Darling Harbour Live – The Haymarket Stage 2 Stage Significant Development Applications (SSDA 4) – Hyder Consulting response to City of Sydney recommendations, Transport for NSW letter and the Department of Planning and Infrastructure comments.

DARLING HARBOUR LIVE

DESIGNERS RESPONSE -

PRELIMINARY ROAD SAFETY AUDIT

FIGURE
SKCPD032

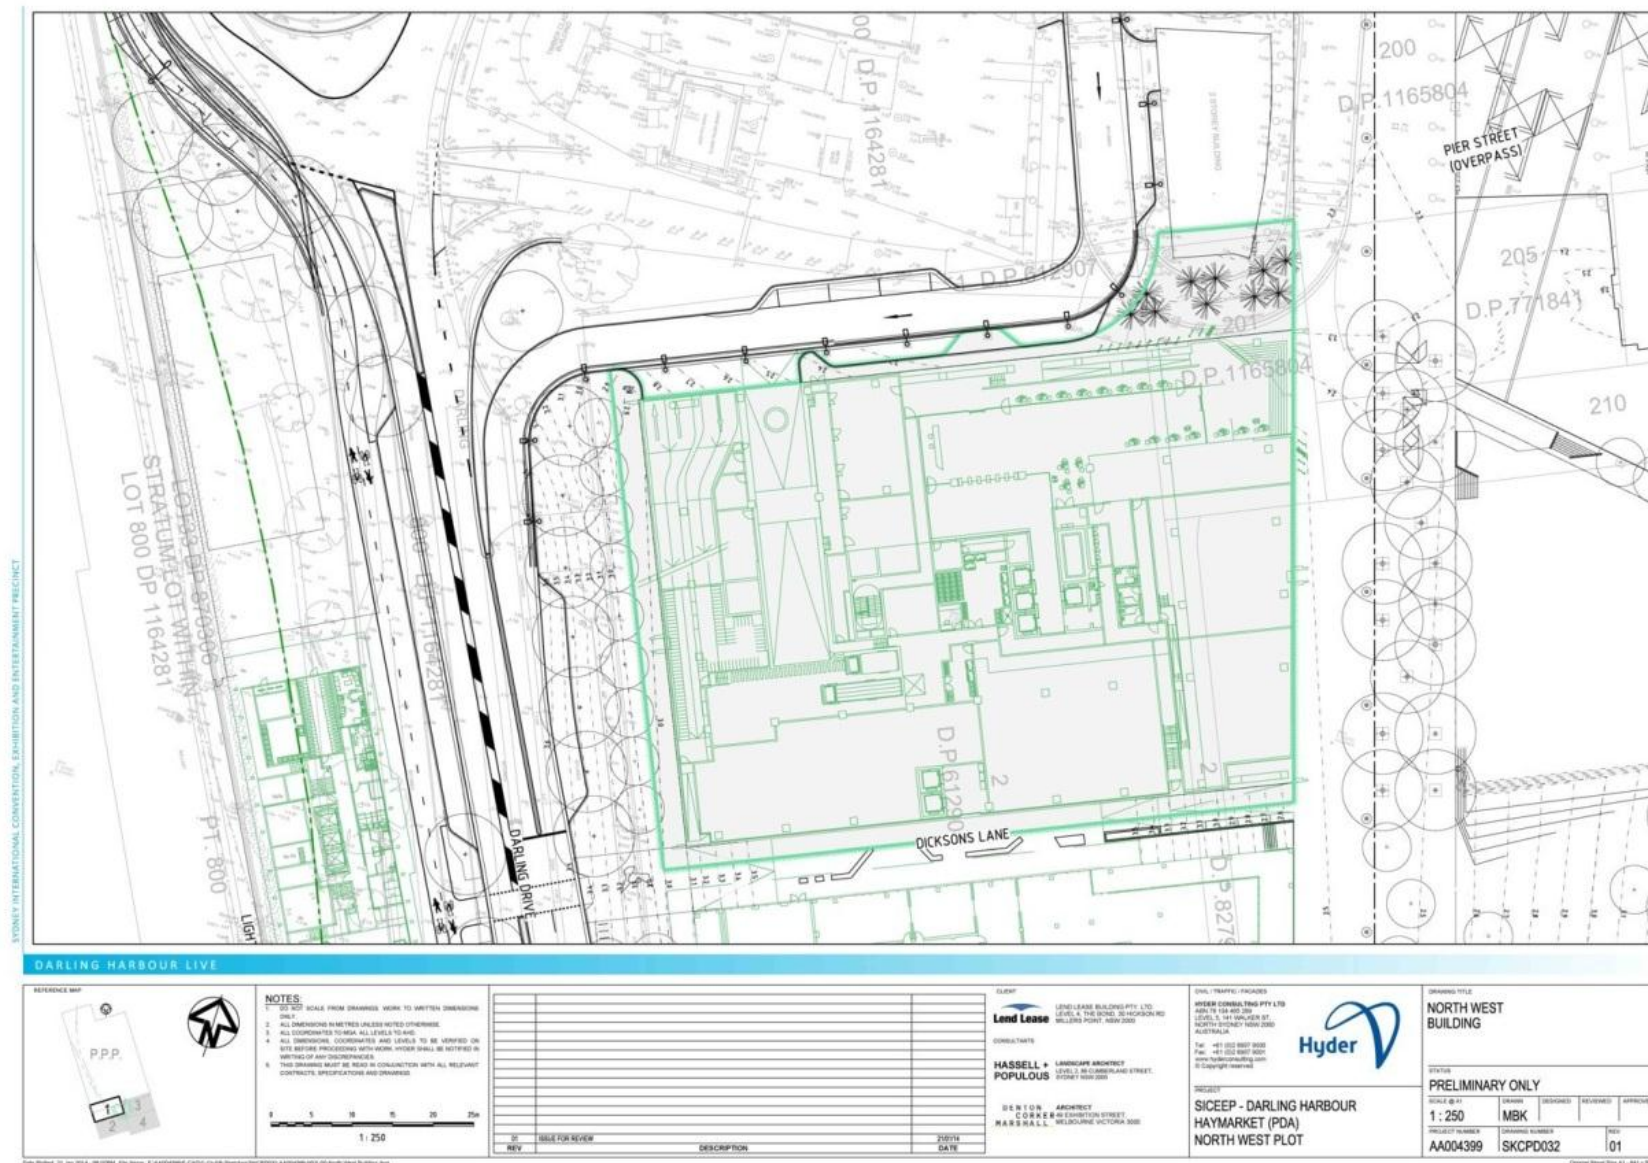
<p>The future cycle network shown for SSDA 2 (the Haymarket precinct (concept) has been superseded and the proposed cycle connections should be based on the current regional bike route map. The proposed cycle connections should be reviewed to ensure consistency</p>	<p>The proposed cycle connections have been reviewed and are consistent with the current regional bike route plan and broadly align with the City Centre Access Strategy of Dec 2013. The enhanced north south connections along Darling Drive and via a through route along the Boulevard, improves connectivity in the precinct as do the east-west cycle routes aligning with the western regional route via Liverpool Street.</p>
<p>Sustainable transport measures</p> <p>Details on end of trip facilities such as showers and changing rooms are required to assist in encouraging active transport is required</p>	<p>End of trip facilities are provided within the North West Plot. Separate Male/Female Showers, Lockers and change rooms are provided on carpark level 1</p>

FIGURE 2

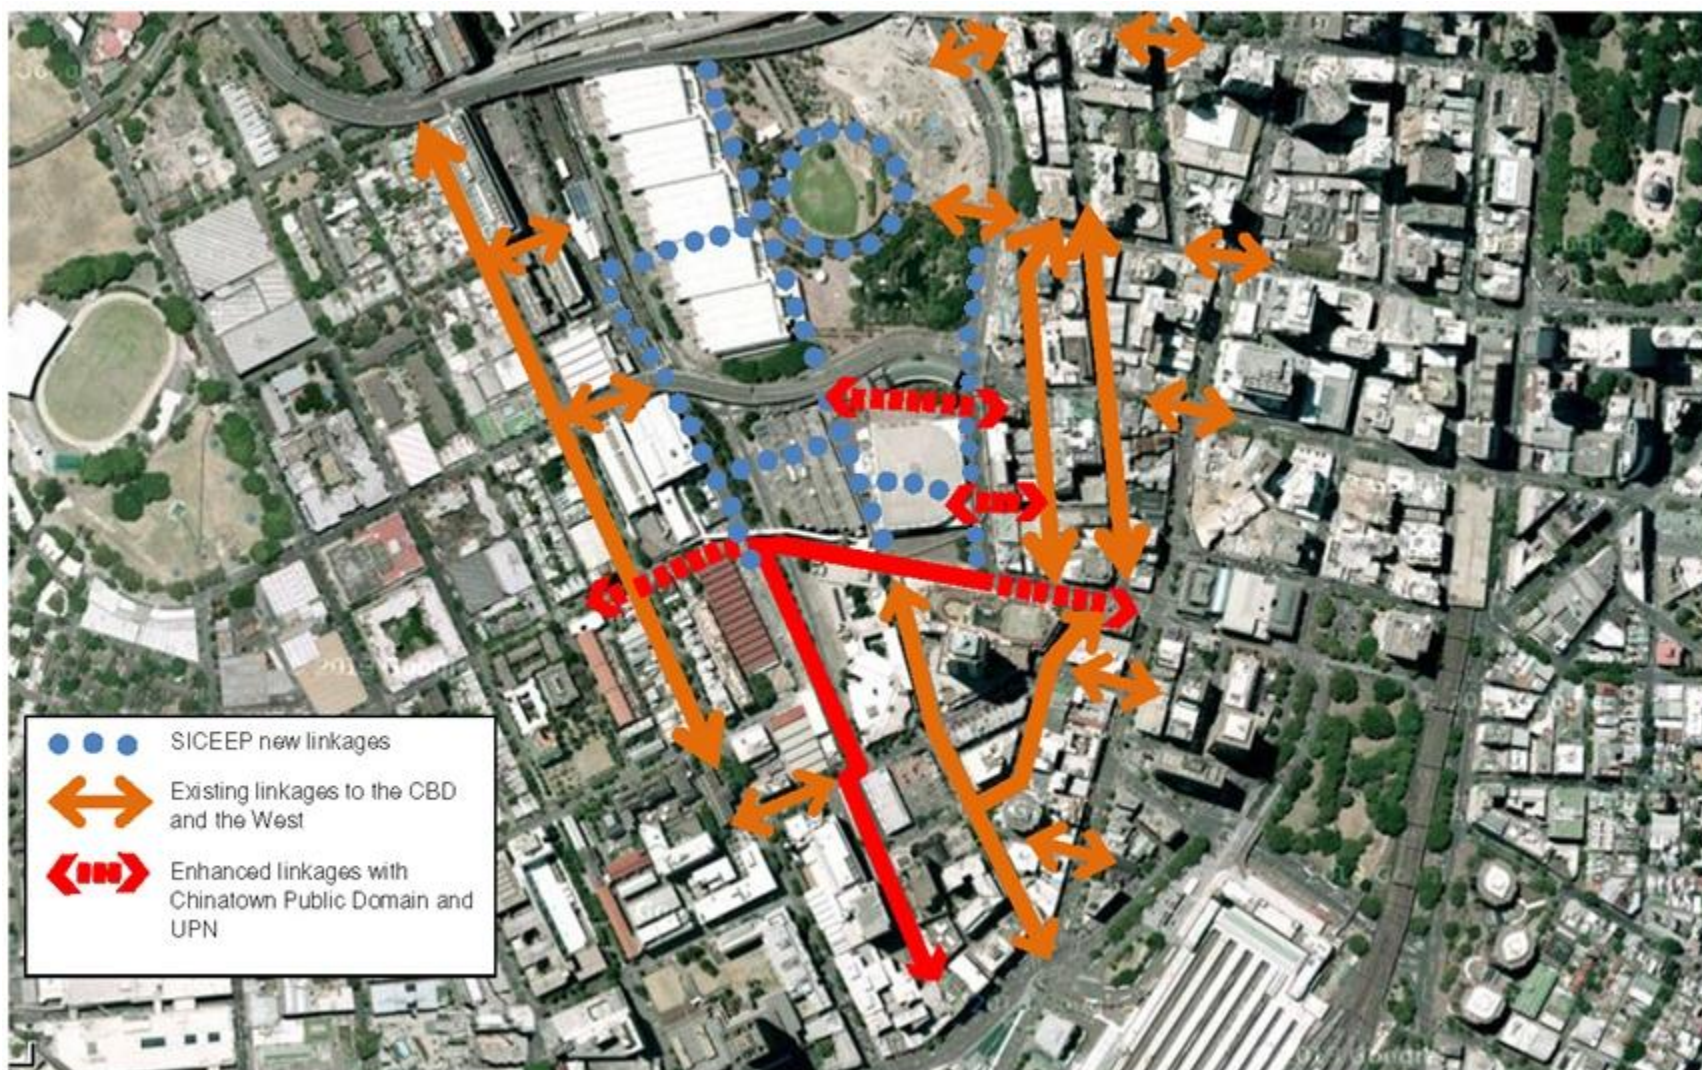
<p>Ensure that there is at grade pedestrian and cycle access which follows the desire line from central station, along Quay Street and then through the SICEEP site to Darling Harbour</p>	<p>At grade pedestrian and cyclist access from central station via Quay Street is provided via existing pedestrian crossings (signalised and informal) along this route as well as the shared zone that is Hay street at the interface of Quay Street and the Southern Precinct. The proposed Boulevard through the Southern Precinct will provide continuous pedestrian and cycle access to Darling Harbour.</p>

Figure1: Revised Theatre layout design

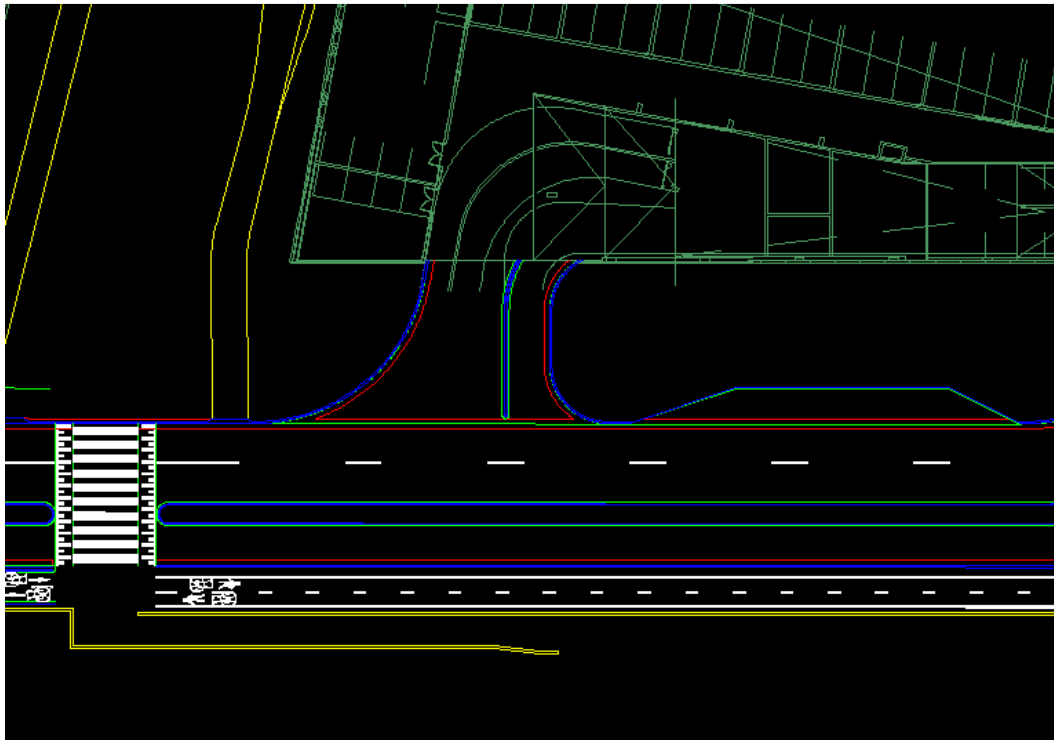
Since the road safety audit was undertaken, there has been a design change in the vicinity of the proposed Theatre car park access and egress. Previously, access for vehicles entering and exiting the Theatre car park, was provided on Exhibition Place. There was a proposed taxi holing zone to the west of the Theatre building, linked to Darling Drive. The pedestrian crossing linking Tumbalong Place and the light rail stop was proposed as either a zebra crossing or a staggered crossing.

Following the change to the Theatre building, access and egress will now be provided to the Theatre car park from Darling Drive. The taxi holing area has been replaced by an indented bus stop and the proposed pedestrian crossing is now proposed as a signalised crossing. Please see Figure 1 below:

We have now reviewed the left-in-left-out access/egress associated with the Theatre car park. We regard this to be a similar set of circumstances as the previously proposed taxi rank as the taxi rank is essentially a left-in-left-out arrangement. As per the audit report we had no issue with the taxi rank. As such, we also have no issue with the current proposal to have a left-in-left-out arrangement for the Theatre car park.
